ULNRC-06109

**DOCKET NUMBER 50-483  
CALLAWAY PLANT UNIT 1  
UNION ELECTRIC CO.  
FACILITY OPERATING LICENSE NPF-30  
RESPONSE TO REQUEST FOR ADDITIONAL INFORMATION RE: PR-03  
AND PR-05, PROPOSED ALTERNATIVES FROM ASME OM CODE PUMP  
AND VALVE TESTING REQUIREMENTS, AND WITHDRAWAL OF  
RELIEF REQUEST PR-05. (TAC NOS. MF2786 AND MF2788)**

**Response to Request For Additional Information (RAI) Regarding Relief Requests PR-03 and PR-05, Proposed Alternatives from ASME OM Code Pump and Valve Testing Requirements**

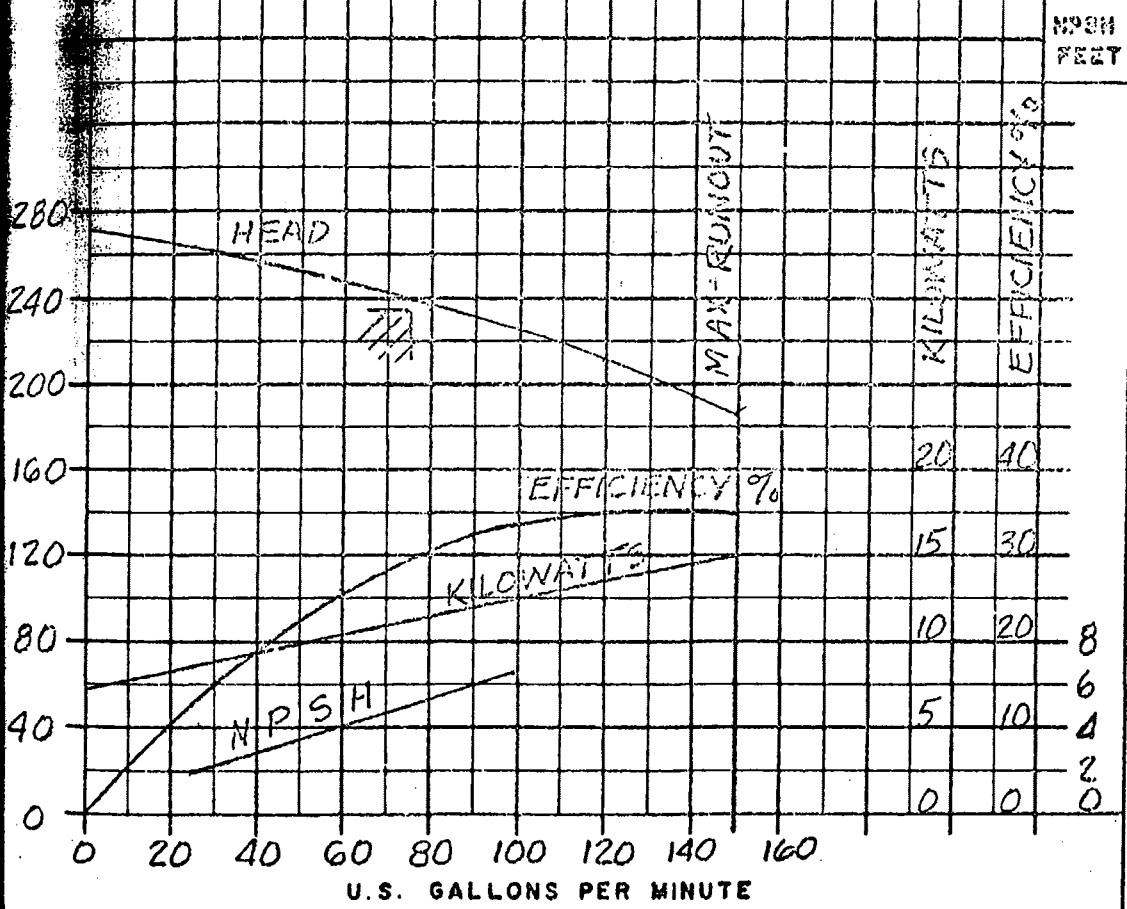
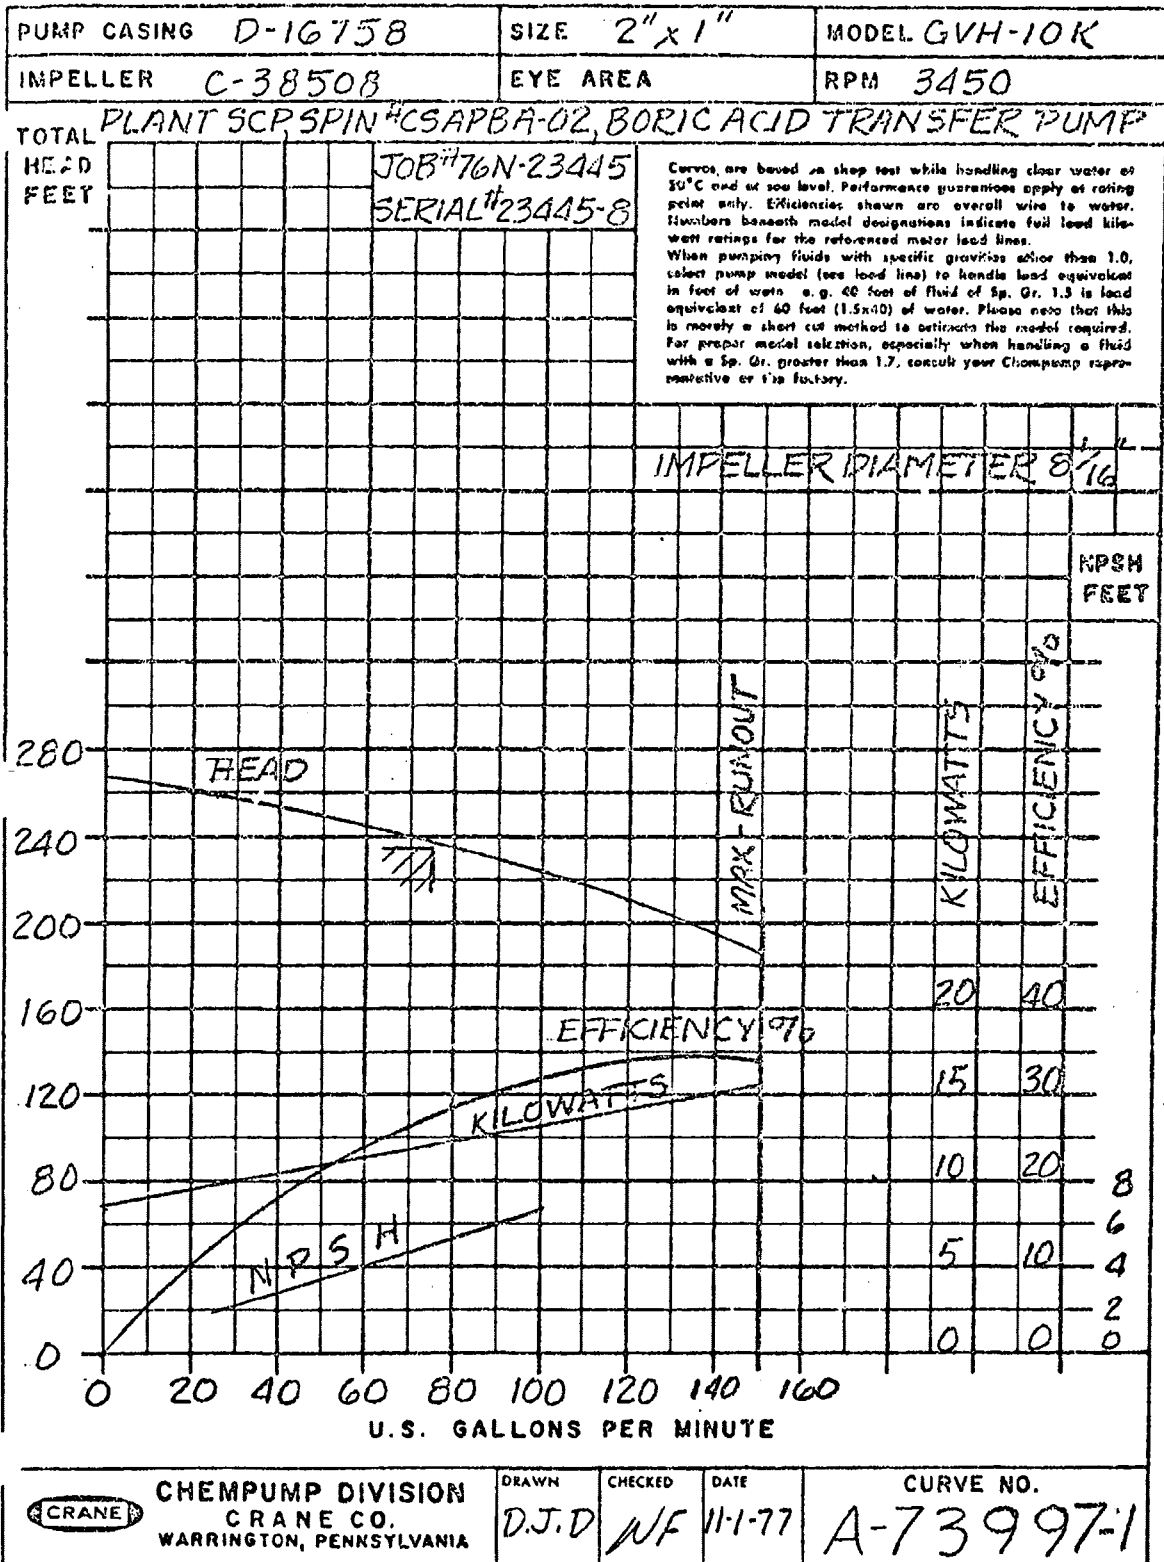
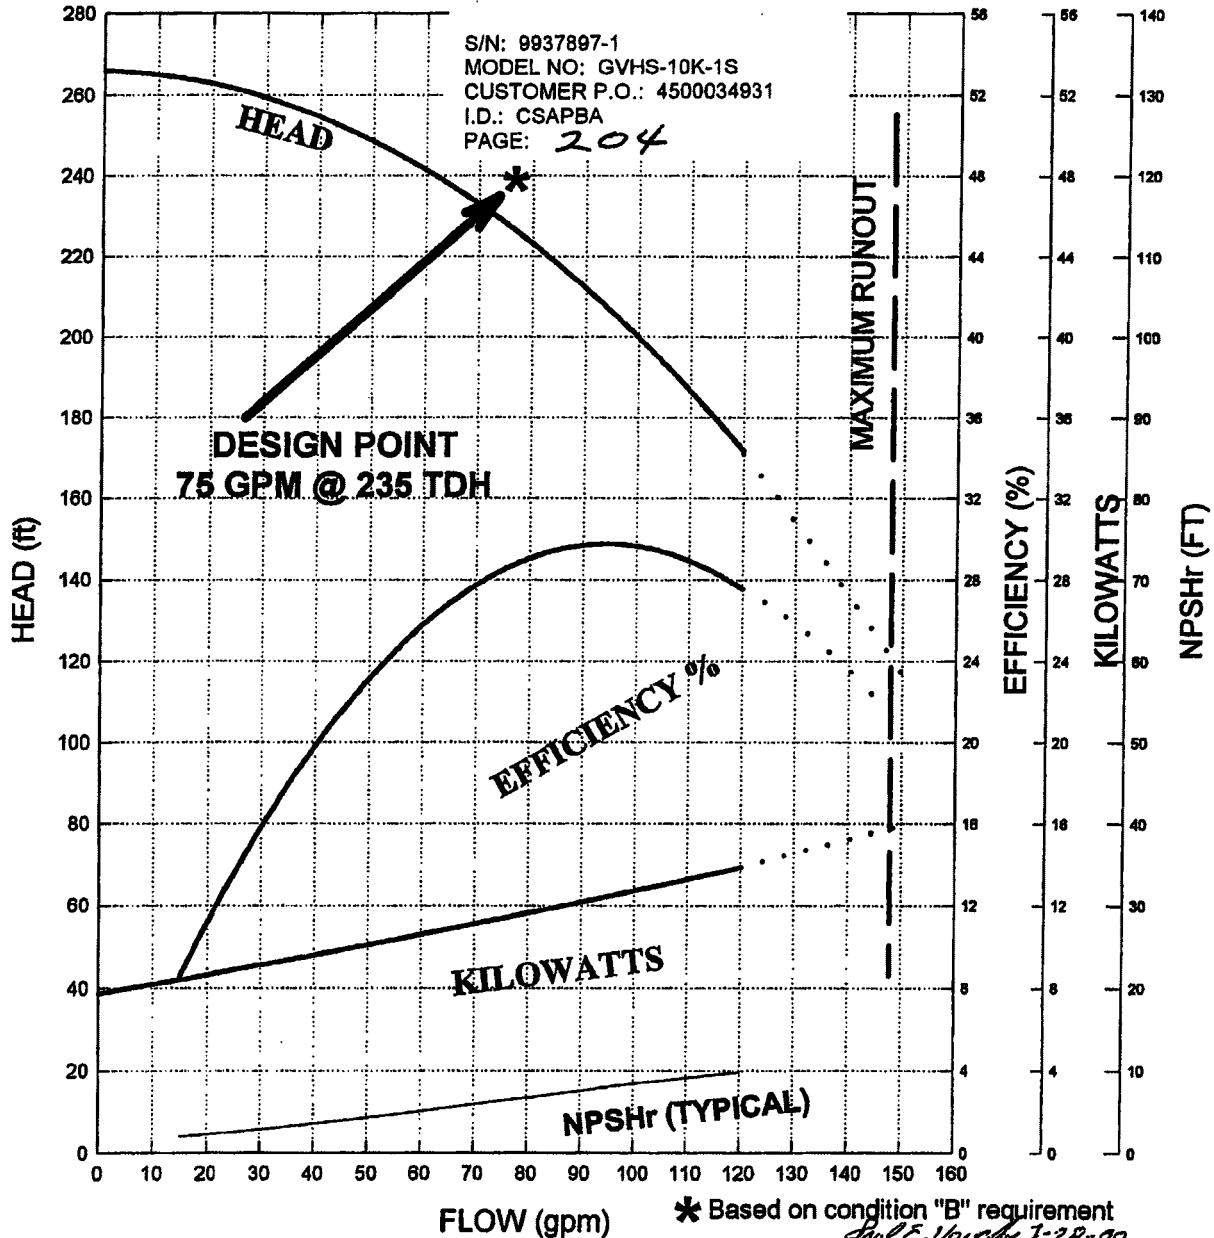
Provide a pump curve for the Boric Acid Transfer Pumps. If the pumps are operating at 15 gpm, are they operating on a flat portion of the curve or a sloped portion of the curve? If they are operating on a flat portion of the curve, discuss how pump degradation can be detected from the proposed Group A test results if flow is not measured.

*Pump curves have been attached with this response. At 15 GPM the pump curves do exhibit some degree of slope/linearity, although not nearly as linear as the 75GPM bi-ennial CPT flow. The lack of flow measurement during quarterly testing does not prevent the detection of pump degradation. Because the throttle position of the applicable globe valve is administratively controlled, the flow rate for the quarterly testing is essentially a fixed value. This is no different than a typical test scenario where flow is measured and adjusted to a fixed reference value.*
